Central-West Orana Renewable Energy Zone Transmission project

Amendment Report

March 2024

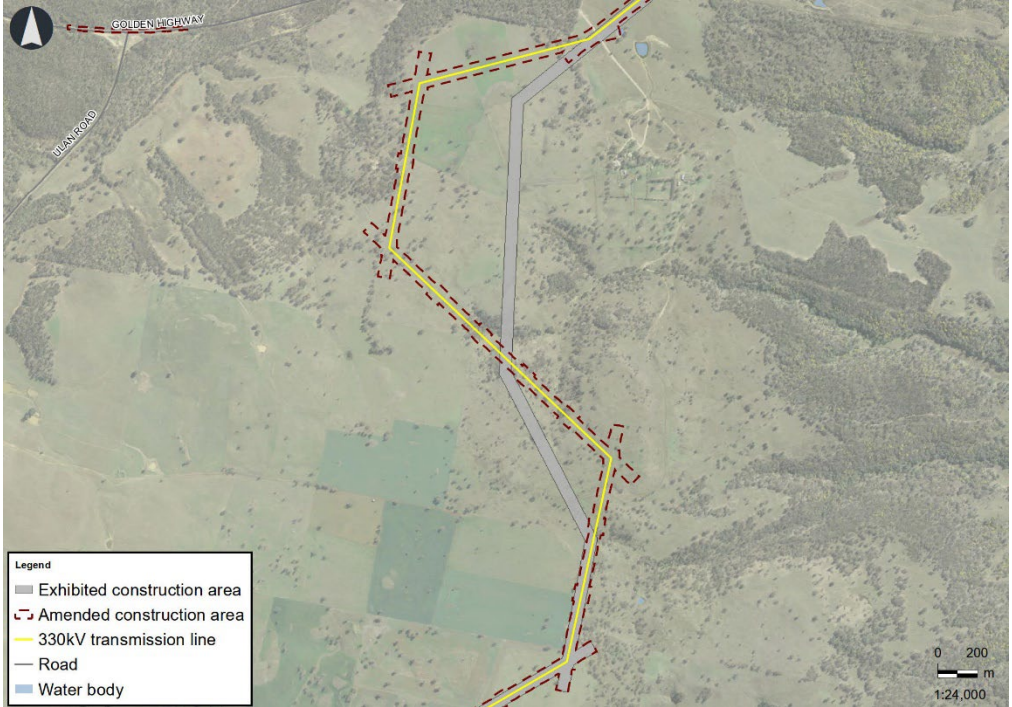
It is proposed to move two sections of the alignment of the 330 kV transmission line just south of Golden Highway, Cassilis to the west and to the east respectively, that would increase the length of the transmission line by around 880 m.

The amendments would respond to feedback received from impacted landowners regarding the transmission line alignment of the exhibited project, and would minimise potential visual impacts of the project at nearby residential dwellings.

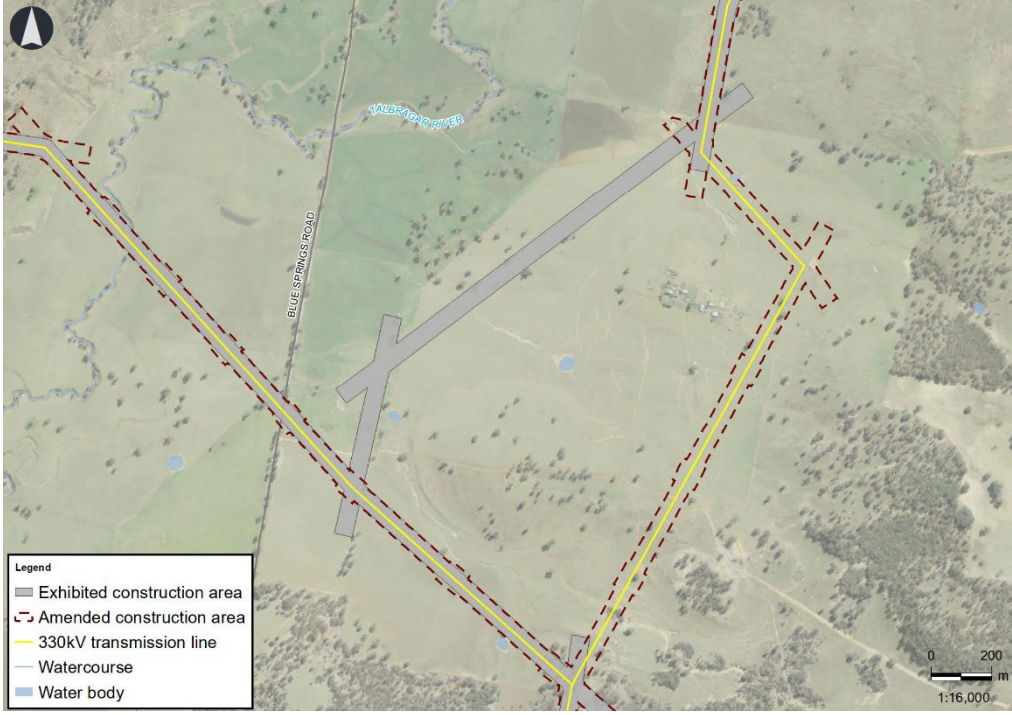
It is proposed to move the alignment of the 330 kV transmission line north of Cliffdale Road, Uarbry to the southeast, that would increase the length of the transmission line by around 1.45 km.

The amendments would respond to feedback received from impacted landowners regarding the transmission line alignment of the exhibited project, and would minimise potential visual impacts of the project at nearby residential dwellings.

Leadville connection and switching station M3

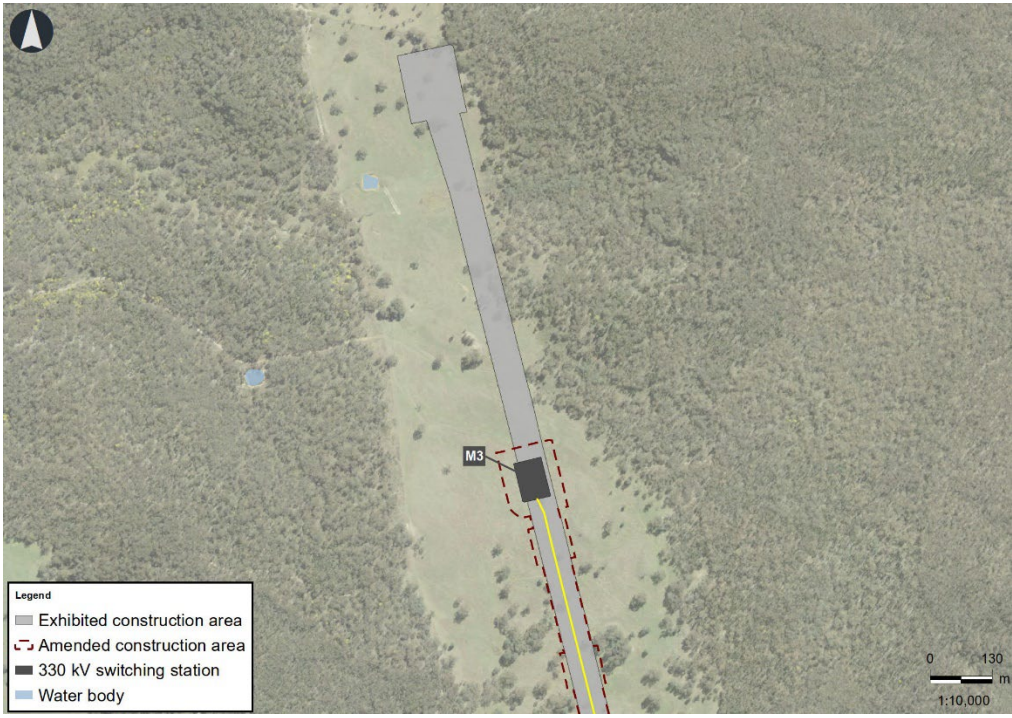
It is proposed to relocate switching station M3 in Leadville to the southeast by around 770 m, that would reduce the length of the 330 kV transmission line by around 820 m to connect to the switching station in its new location.

The amendments would respond to feedback received from the Valley of the Winds wind farm developer.

New 330 kV transmission line and switching station E5

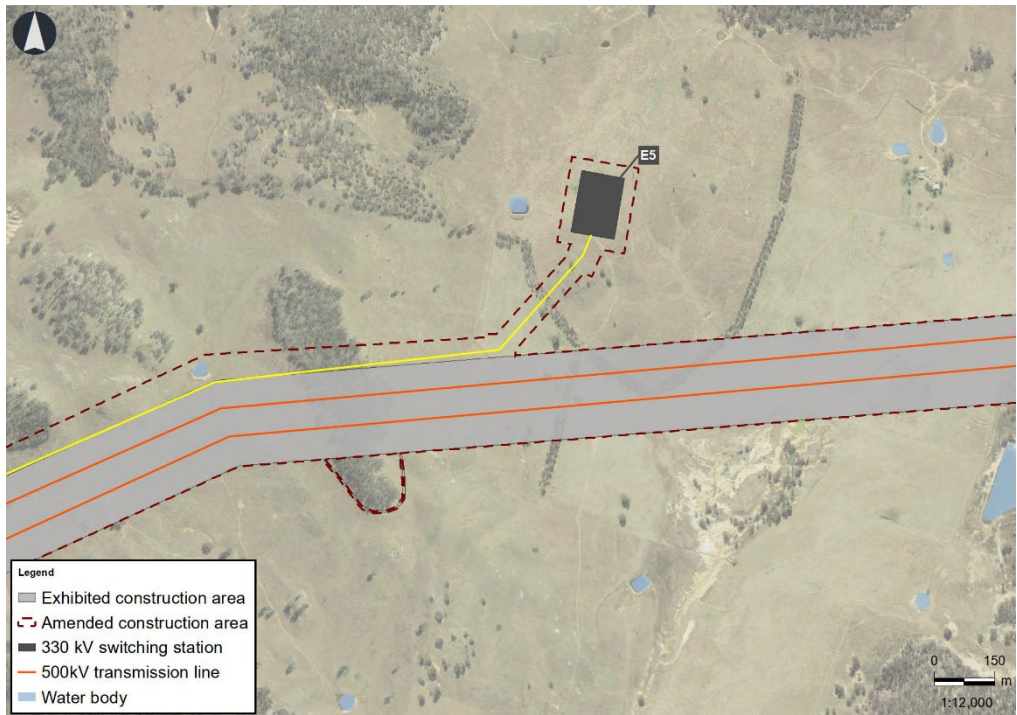
It is proposed to provide additional 330 kV transmission infrastructure as part of the project to connect to the western cluster of the proposed Orana wind farm project. The additional 330 kV transmission infrastructure would consist of a single circuit 330 kV transmission line extending eastwards for around seven kilometres from the Elong Elong Energy Hub to a new switching station E5 (referred to as the Dunedoo connection).

The amendments would respond to feedback received from the Orana wind farm developer.

Cobbora north connection and switching station E1

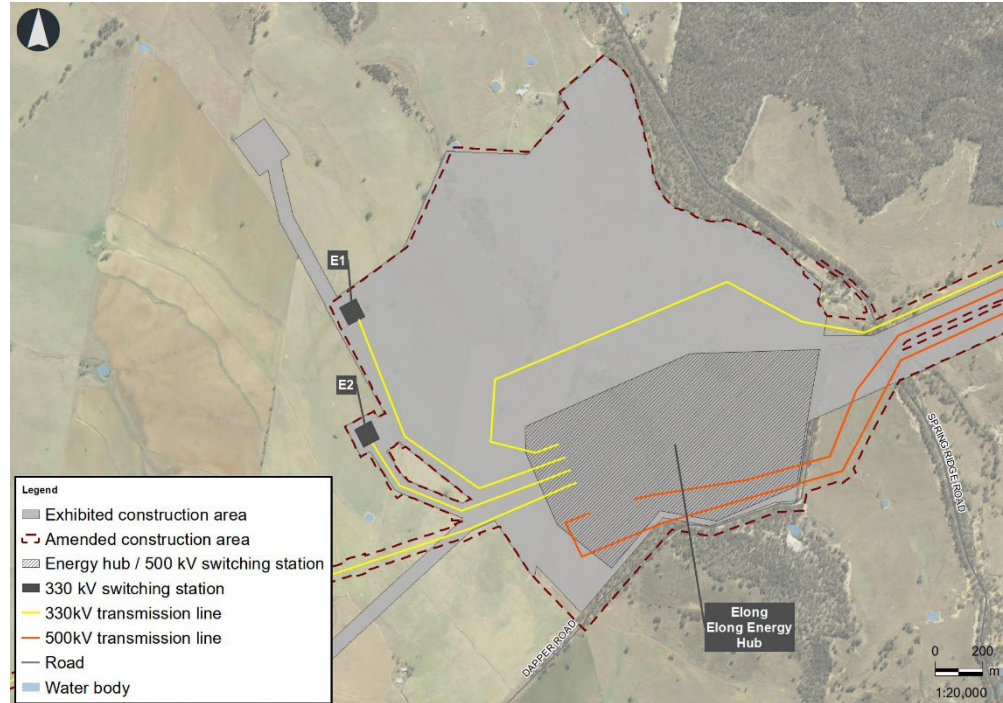
It is proposed to relocate switching station E1 around 690 m to the southeast. This would reduce the length of the 330 kV transmission line by around 755 m to connect to the switching station in its new location.

The amendments would respond to feedback received from the Cobbora solar farm developer regarding the location of switching station E1 and the alignment of its associated transmission line in the exhibited project.

Goolma connection and switching station E4

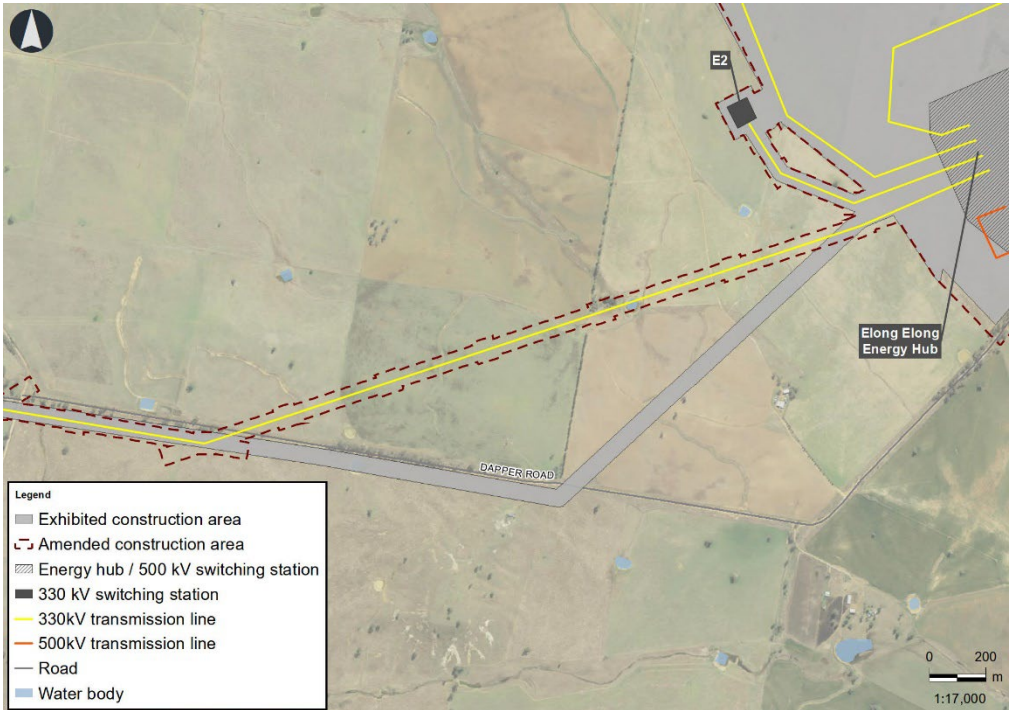
It is proposed to move the 330 kV transmission line alignment of the Goolma connection east of the Elong Elong Energy Hub to the north, that would reduce the length of this transmission line by around 260 m.

The amendments would respond to feedback received from impacted landowners regarding the transmission line alignment of the exhibited project, and would minimise potential visual impacts of the project at nearby residential dwellings.

Figure 3-2
Indicative layout of the construction
compound at Neeleys Lane
workforce accommodation camp

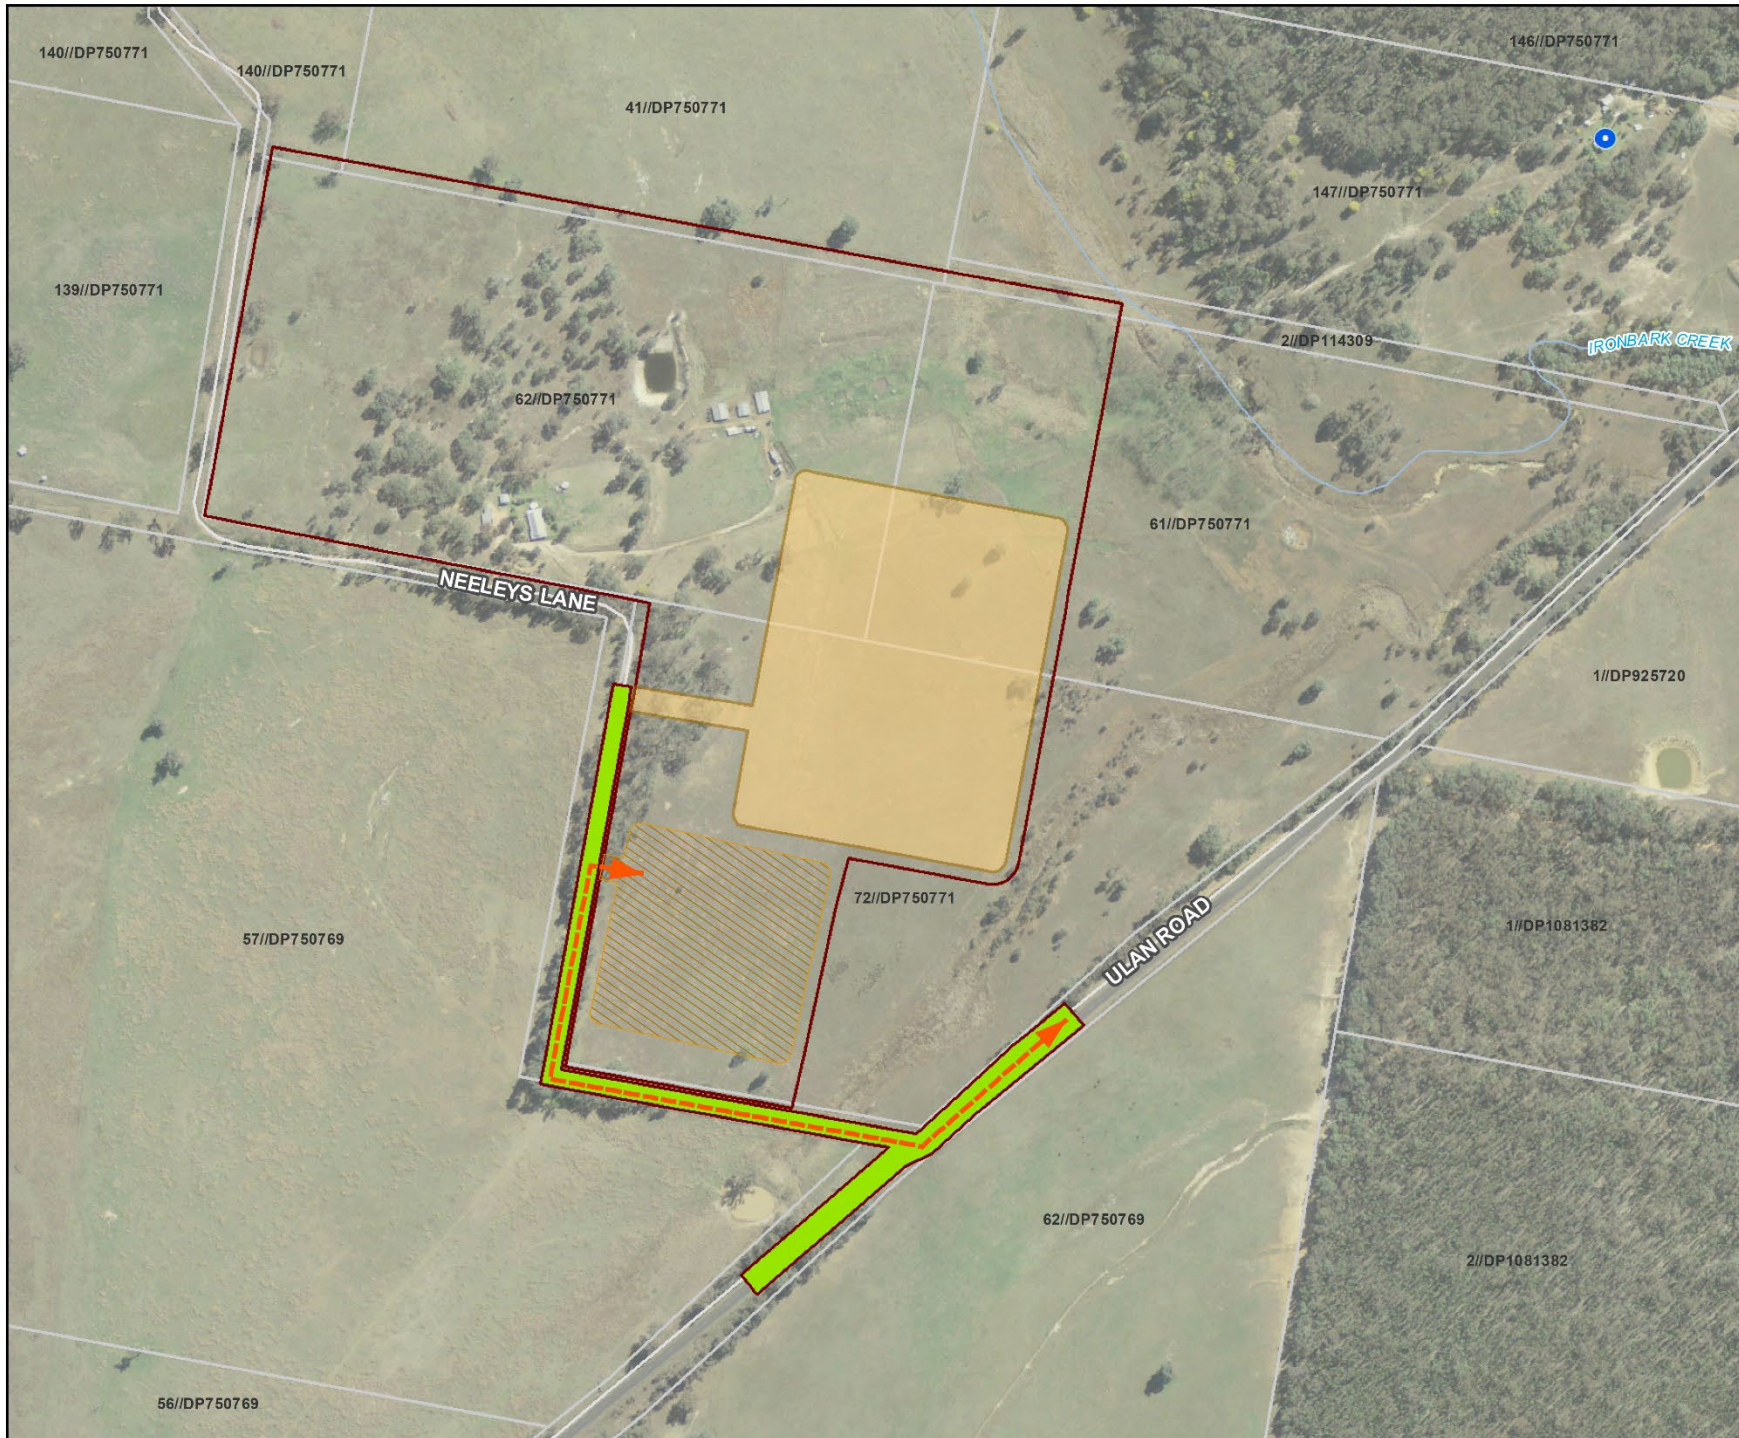
As a result of further development of the construction methodology of the project, a construction compound is proposed at the Neeleys Lane workforce accommodation camp. The construction compound would be provided within the construction area of the exhibited project and would include materials storage and laydown facilities, staff facilities (office, lunch room and amenities), aggregate bins, workshops, parking areas and fencing. The use of the construction compound in this location would be consistent with the proposed hours of construction identified in the EIS.

Figure 3-2 shows the location of the construction compound at the Neeleys Lane workforce accommodation camp.

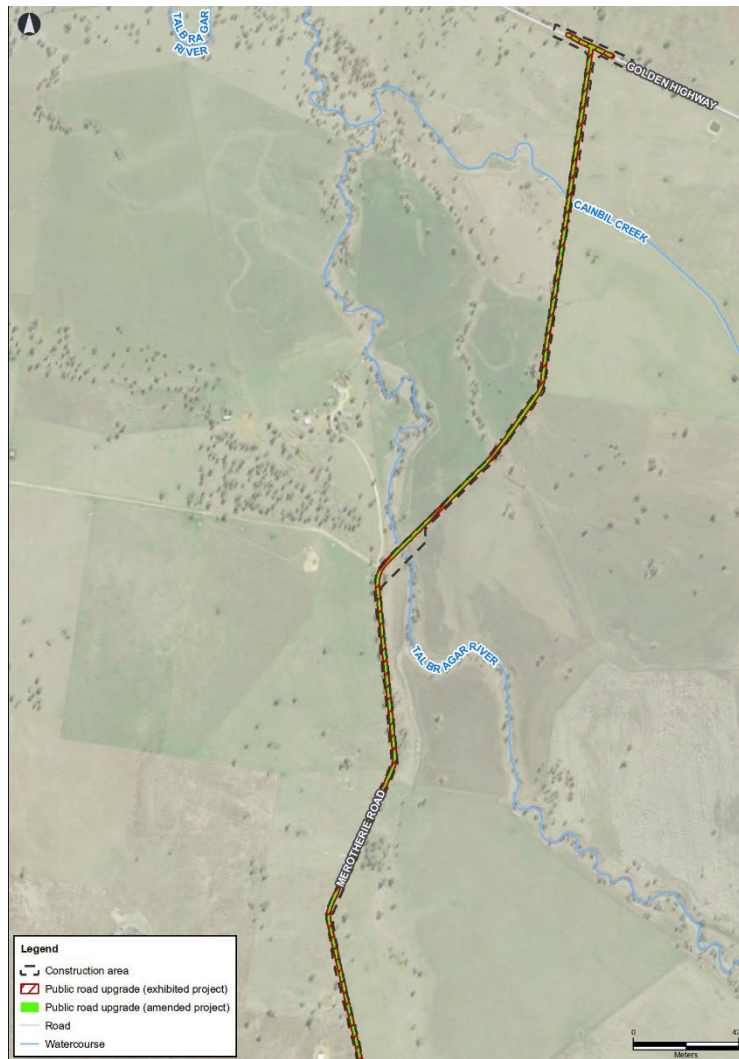
Changes to the extent and alignment of the Merotherie Road upgrade and the upgrade of the intersection of Merotherie Road with the access road to the Merotherie Energy Hub.

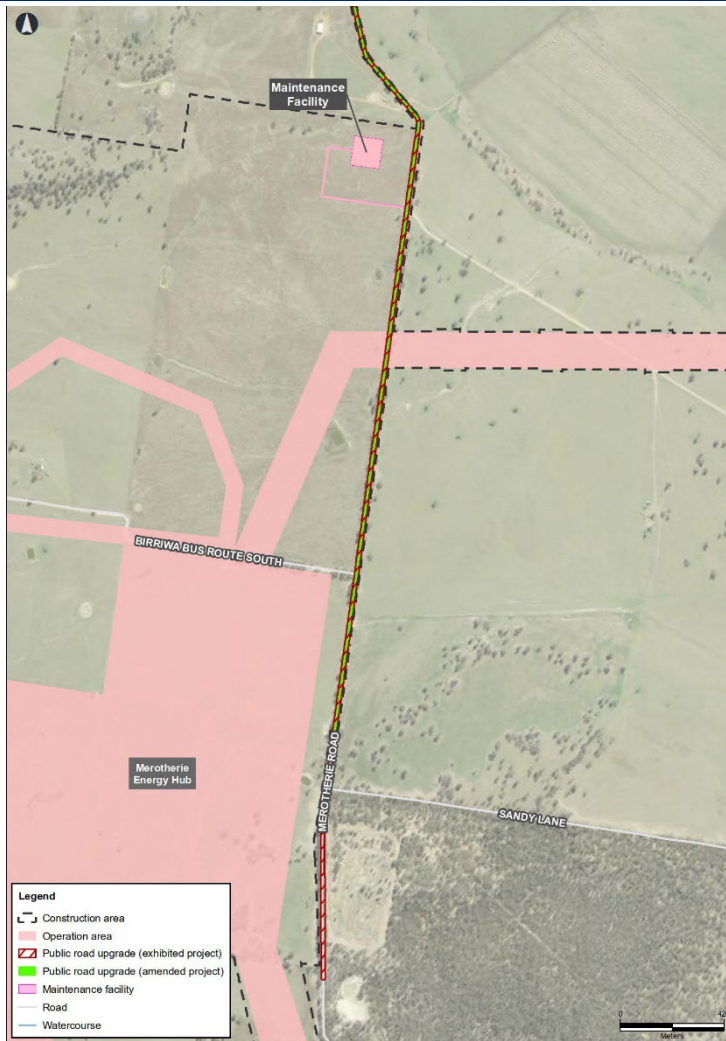
Installation of new bridge on Merotherie Road at its crossing of the Talbragar River to replace the existing crossing.

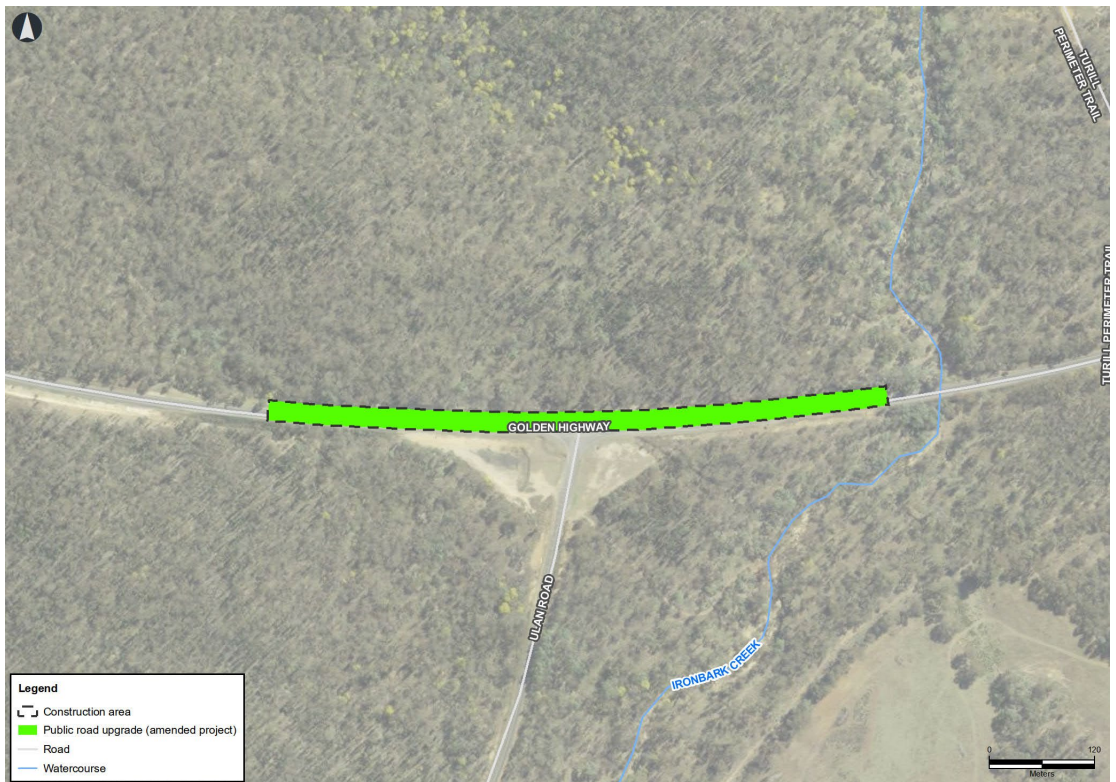
Changes to the extent and alignment of the Spring Ridge Road and Dapper Road upgrades, and the Spring Ridge Road/Dapper Road intersection upgrade. Installing a new bridge on Spring Ridge Road at its crossing of Laheys Creek to replace the existing causeway.
